## SCHEDULE OF MODIFICATIONS

### Submissions Received from Public – Wishart Place Structure Plan Amendment – PLN.37 - No. 91 (Lot 371) Horsley Road, Denmark

21 July 2020 - Attachment 8.1.1b

Submission 1 (S1) – Attachment A -

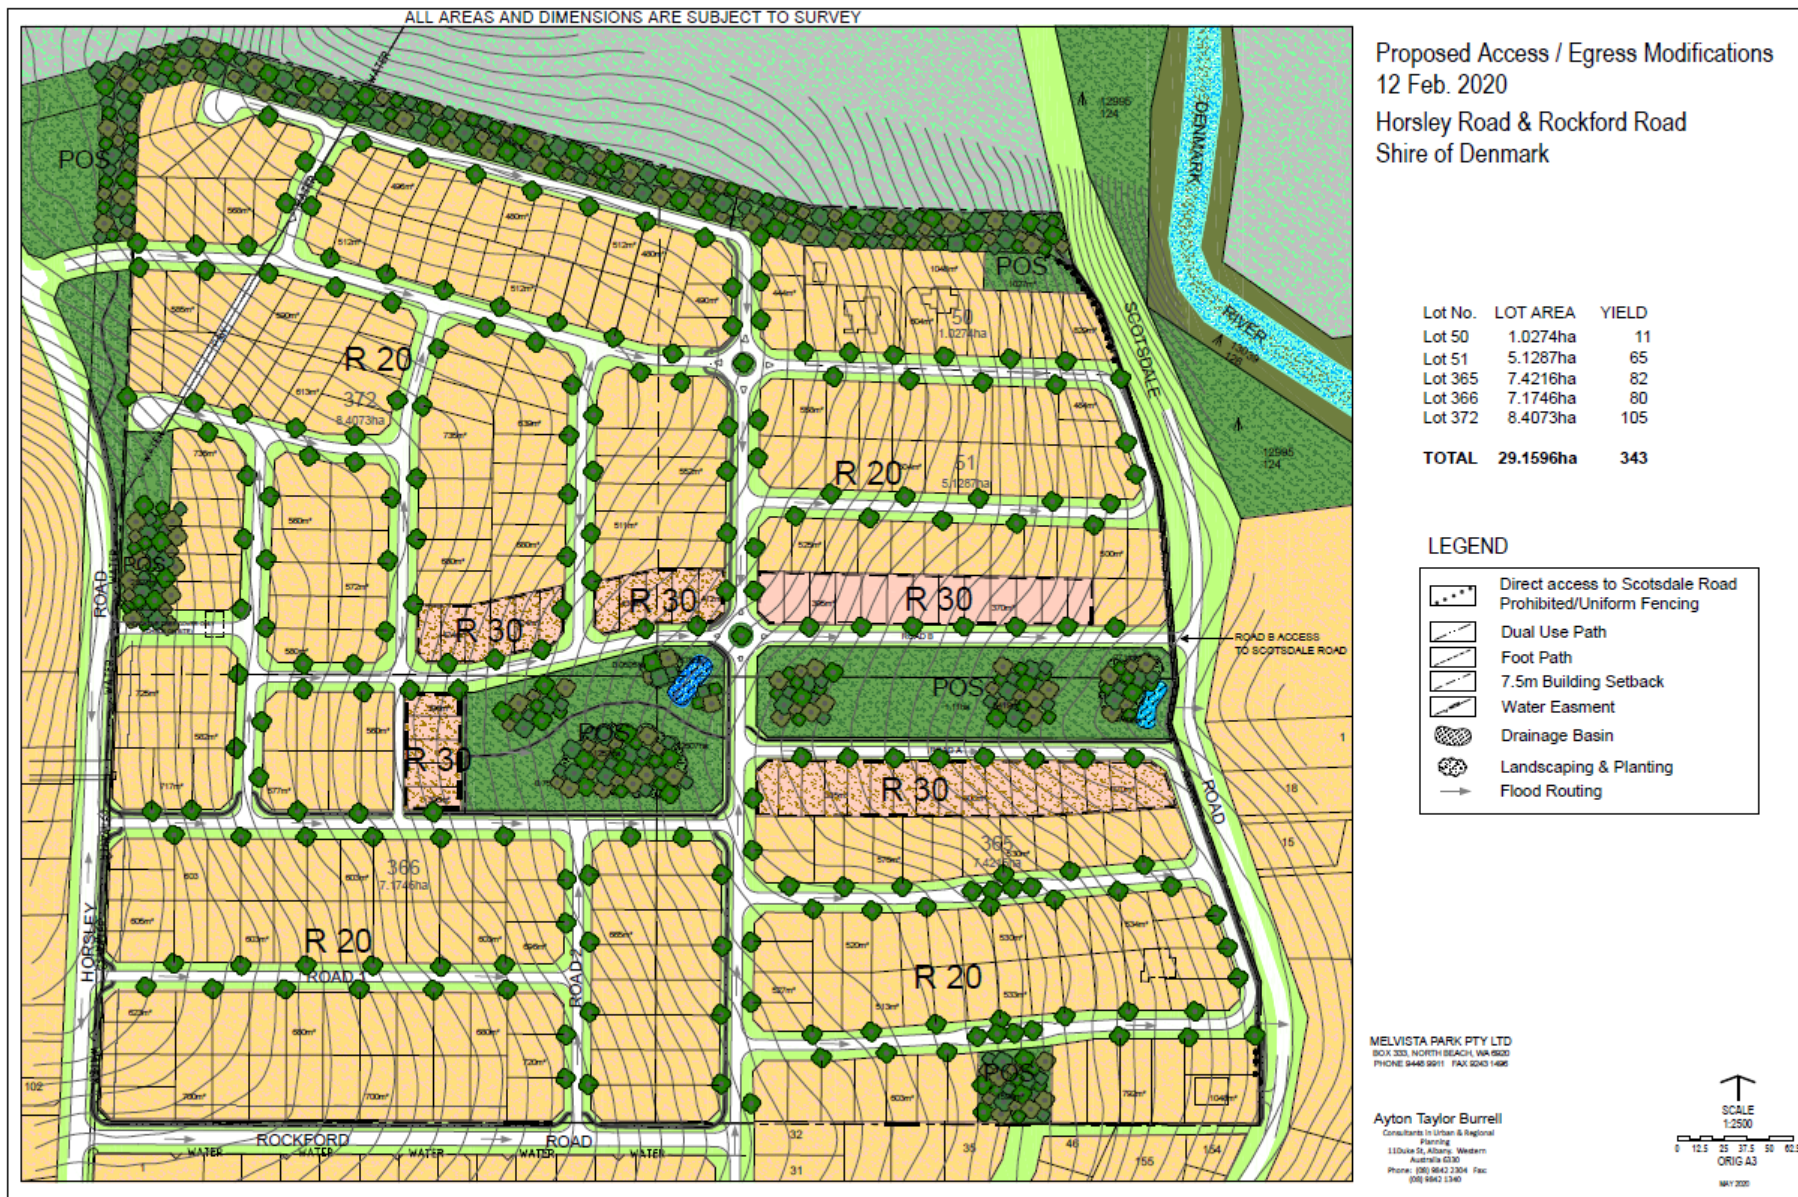
<p>relatively recent, being dated 29 July 2019, and it shows an incorrect road connection into lot 372. Had the designer taken notice of the adopted Horsley/Rockford LSP (adopted 18 May 2012) then the correct road connection would have been shown. This adopted road connection is shown as a T Junction on a section of Horsley Road realigned through lot 371 to preclude tree removal in Horsley Road and avoid a wet area. Had this adopted connection been shown on any plan relating to lot 371 then the proposed internal T Junction on that lot would not have been shown, unless a dangerous four way intersection was proposed. Any departure from road arrangements consolidated in the adopted Horsley/Rockford LSP needs to be justified.</p> <p>3. In the Introduction, reference is made to the reason for the change ie removal of remnant vegetation and the solar passive orientation of lots. The remnant vegetation notation on Figure 2 generally corresponds with existing canopy but does not identify specific tree trunk locations. This area of Marri trees will be removed regardless of which plan is implemented ie some because of road construction and others to achieve house construction and solar passive objectives. It would appear therefore that the applicant is avoiding extending Horsley Road for approximately 100m, as shown in Figure 3 and the adopted Horsley/Rockford Road Structure Plan. It would be prudent for Shire staff to carry out a site inspection to determine the bona fides of this proposed modification.</p> <p>It is imperative that any new or varied structure plan corresponds with adopted structure plans. We are most concerned about access and egress at lots 372 and 51 in view of the Amaroo retirement village prospect, as stated in our letter to you dated 3 February 2020. In early February we commenced looking at improving access/egress arrangements and our team has concluded the best option in regard to Horsley Road is to construct an entry road into lot 372 approximately 30 m north of its southern boundary. That location, which generally coincides with our crossover, avoids removal of trees and includes filling and grading to reduce the gradient. We are presently examining fill proposals for proposed adjoining lots to ensure they are not below proposed road level. Our proposed road location unfortunately coincides with the lot 371 proposal. We have negligible alternatives whereas lot 371 can adhere to</p>	<p><b>Upheld</b> Adjustments to the road system need to be made to acknowledge adjustments may be required to protect trees in the Horsley Road reserve and the location of the southern most entry adjusted as per the recommendations in the attached Council report.</p> <p><b>Noted</b> It is understood that in either version of the structure plan (original or proposed) that most trees on private property would be removed.</p> <p><b>Upheld</b> Further discussions and design options were explored with the applicant in response to the need to adjust access into the Horsley/Rockford Road Structure Plan area.</p> <p>This is addressed in the Council report and has resulted in a recommended modification to shift the intersection in question north, place traffic islands and design for suitable sized trucks in a manner that complies with the requirements of Austroads standards.</p>

<p>the original access proposal 100m to the north along Horsley Road. We will pay half the cost of the tree removal in Horsley Road to assist with this road extension.</p> <p>It would appear the time is ideal to revisit road alignment arrangements for both the Lot 371 area and the overall Horsley/Rockford Local Structure Plan area, with or without a retirement village. Up to now these plans have been prepared independently and a collective approach is desirable.</p> <p>Following on from the email I sent you on 12 May I provide the following information.</p> <p>In early February this year I commenced making some draft modifications to the Horsley/Rockford Road Local Structure Plan (HRRLSP) as a result of (i) lot 366 possibly being set aside for a retirement village purposes and denying access to lot 372 and (ii) the intention of the owner of lot 365 to not proceed with development. Note: lot 365 was included in the HRRLSP adopted in 2012. Dick Dimmock's parents Geoff and Joan, the then owners of lot 365, were part of a group effort to structure plan and rezone the land from 2005 through to 2012. After the adoption of the structure plan the control of lot 365 passed to Dick who elected not to participate in subsequent rezoning to Residential.</p> <p>It is opportune to review both structure plans to arrive at the most suitable road layout.</p> <p>NB Attachments are provided at the end of this schedule that highlight various issues raised..</p>	<p>Noted</p> <p>Noted Staff are will to work with the landowners within the Horsley/Rockford Road Structure Plan area to amend this structure plan and bring it up to speed with contemporary planning principles.</p>

Submission 2 (S2) - Attachment 1

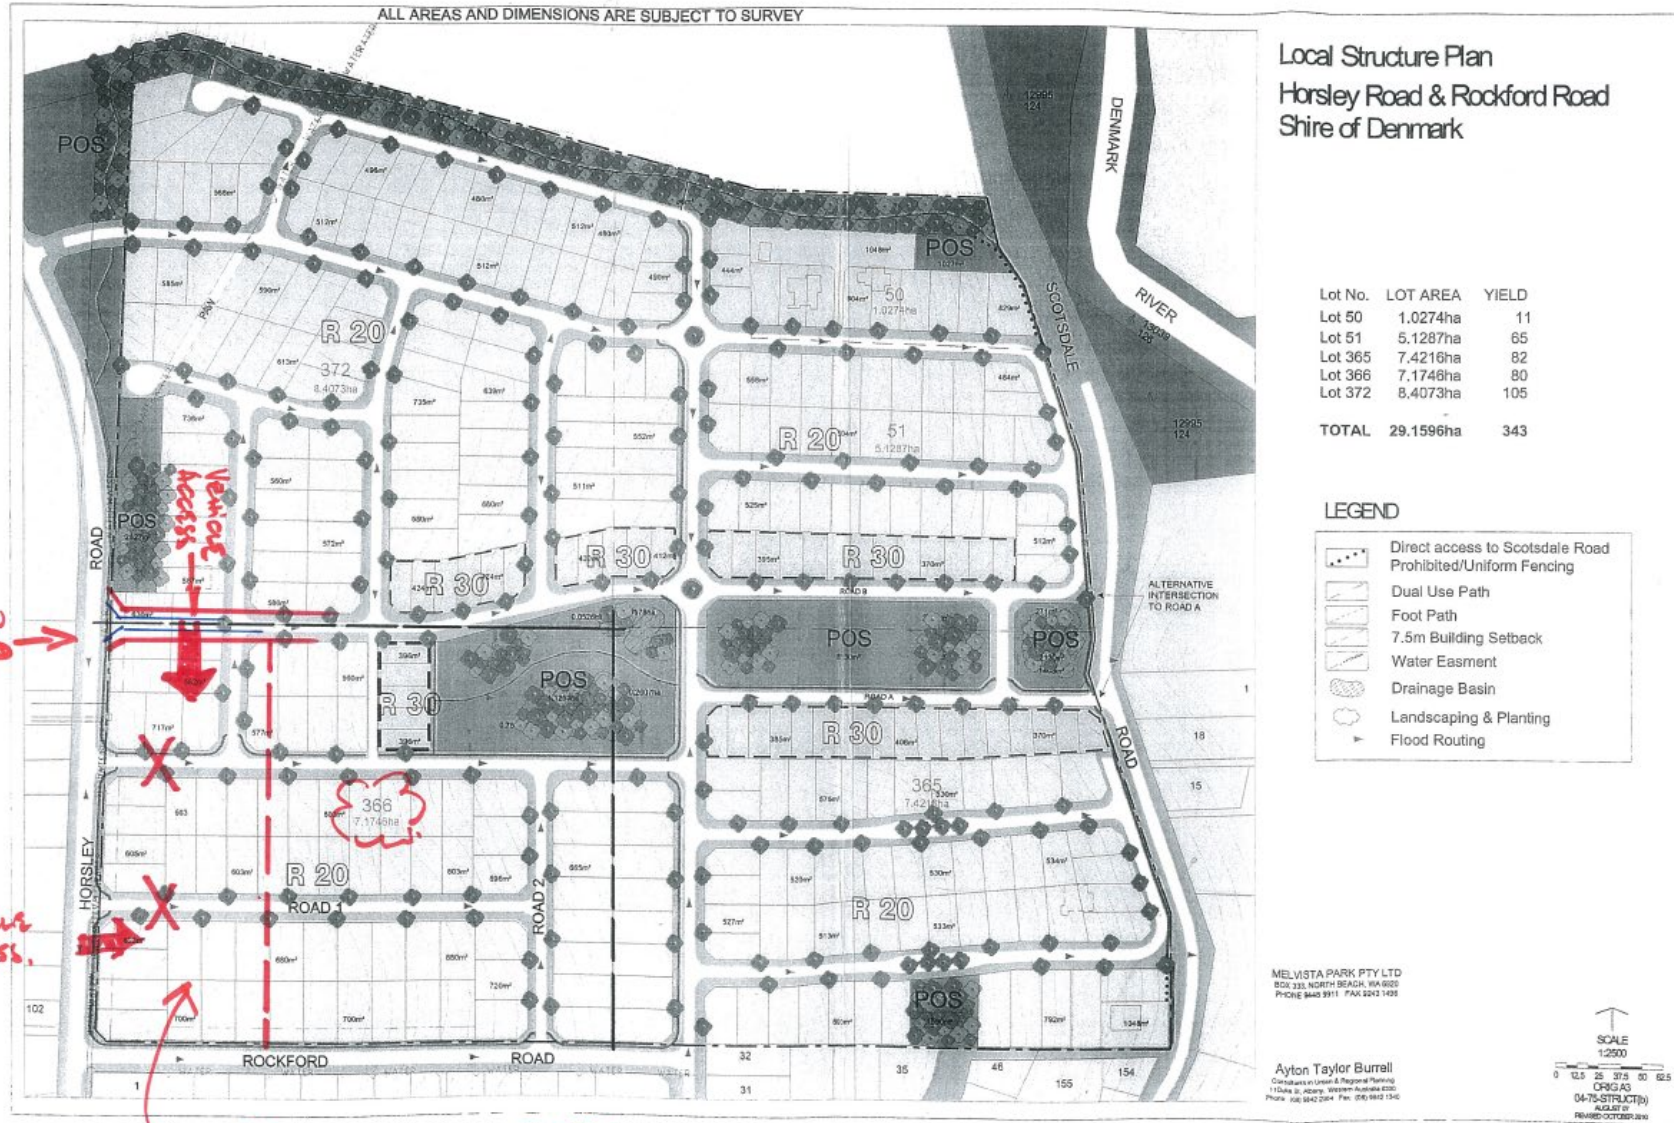
<p>along the proposed development boundary.</p> <p>It is the second vehicular access point that is of concern. In order to make this work, Amaroo would have sought a change to the Structure plan for Lot 366 (which we would have to do anyway), proposing that the connecting road to Horsely, moves northwards, to align with the common boundary between Lots 366 and Lot 372.</p> <p>This is the only location where the road alignment will work. However, if it is located in this position, then it will likely be too close, if not to directly coincide, to the proposed new road intersection on Horsely, for Lot 371.</p> <p>Strategically, Amaroo will be lodging an Application for Development Approval (DA), without requiring any subdivision of the land. The DA will propose an amendment to the Structure Plan, to show that the development can be done without adversely affecting the integrity of the Structure Plan, but may not seek to change it at this stage, depending on the requirements of the Shire.</p> <p>Accordingly Amaroo would object to the amendment to the road change on Lot 371 as it may cause traffic conflict with the proposed road changes to Lot 366.</p> <p>However, there are also other planning design issues to do with the amendment to Lot 371, but these do not directly impact Amaroo and are of more direct adverse impact on the landowners either adjoining or future developed Lots on 371.</p> <p>These issues include;</p> <ul style="list-style-type: none"> <li>• Lot 25 Horsely Rd Landowner: I would have thought that this landowner would object if they realised that they would have a road on their boundary, rather than other residential Lots. I had heard that he had been gravely ill recently, perhaps they had not received the correspondence or had</li> </ul>	<p>Noted</p> <p>The Structure Planning amendments that would result from the proposed Aged Persons Village should commence prior to lodging a development application to allow for suitable time to assess the wider impacts of changing the adopted structure plan.</p> <p>The owner of Lot 25 indicated before the lodging of the structure plan amendment that they had no objection to the road shifting to beside their boundary.</p>

<p>not thought it important with other concerns.</p> <ul style="list-style-type: none"> <li>Greater long term loss of vegetation Whilst the proposed new road alignment appears to "save trees", the current road location doesn't appear to actually cause a loss of trees - it is mostly canopy which appears on aerial photography. However, if the proposed road/ Lot layout is adopted it seems almost certain that with the development of houses and the like, that most of the tree stand would be jeopardised. A more detailed assessment could evaluate this aspect.</li> <li>Interface with Water Corp site - an impact assessment of the visual appearance of the Water Corp site and how this is addressed from the point of view of vehicular traffic should be undertaken. From a Planning perspective, is it a better aesthetic solution to have a road alongside the water Corp Site, or is it better to have housing allotments back on to it and screen it from traffic and public view?</li> </ul> <p>It appears that perhaps the Planning Unit Band Horsely/Rockford Roads Structure Plans may have been undertaken some time ago and that various minor amendments over the nearby landholdings may now be advisable due to changing circumstances with landowners . Perhaps all affected landowners may be contacted and invited to undertake a single exercise to update the respective Structure Plans.</p> <p>Thank you for your consideration.</p>	<p>Noted As noted above, it is understood that in either version of the structure plan (original or proposed) that most trees on private property would be removed.</p> <p>Noted The portion of the Water Corporation site that abuts the planned road is remnant vegetation. Adjusting the road to this location will allow the road to buffer the residential lots to this vegetation for fire management purposes.</p> <p>Noted This is an option for Council, but staff have recommended that the minor adjustments proposed to the current structure plan can be made without unduly affecting the development potential of the neighbouring land.</p>
